## The New 2005 Sail Identification Diagram

## Diagram of MYA Prescription Information

### DIAGRAM as RRS E6 WITH MYA RECOMMENDATIONS IN BOLD ITALICS

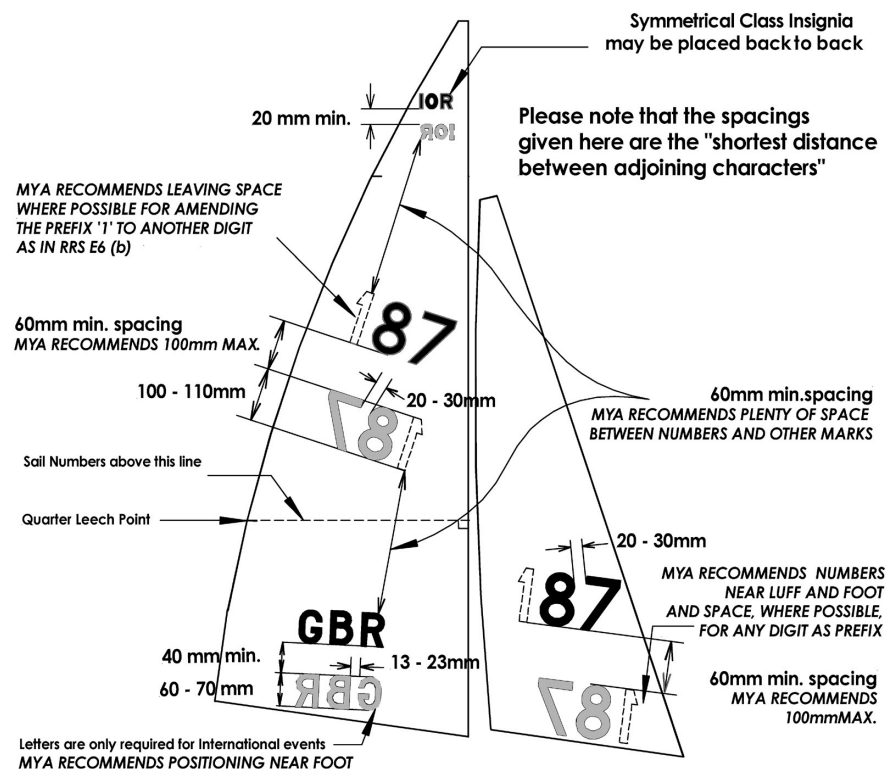
The intention of the change is to make the recognition of numbers easier, particularly at distance. The most important difference from the previous 'RSD recommended text' of 2002 is a greater distance between the individual characters of the sail number, now 20-30 millimetres. There is also greater space for the placing of numbers on small sails generated by a new priority of relaxation of the positioning requirements for small sails only.

One of the MYA recommendations in the new diagram concerns the space left for a prefix in front of the two digit number. In big events there can often be several conflicts caused by more than one boat with the same two digit number. Where space permits, it is recommended that you allow space not just for the prefix '1', which is a requirement of the RRS, but also that you make this space big enough for a larger number in order to help the solving of conflicts.

The MYA has also responded to the problem of symmetrical numbers, like 01 being read as 10 etc. The 2005 MYA SSIs will include a requirement that these numbers are treated as being in conflict with themselves, without a similar number on a different boat being present. A prefix '1' will be required for the symmetrical numbers 01, 08, 10, 18, 80, and 81 with the intention of removing the confusion often occurs and which can be so infuriating and unfair at times.

MYA regards the symmetrical numbers 01, 08, 10, 18, 80 and 81 on a sail as causing 'conflict'. MYA SSIs require that these numbers shall always display a prefix '1', unless the number requires an amendment at an event in accordance with RRS E6(b).
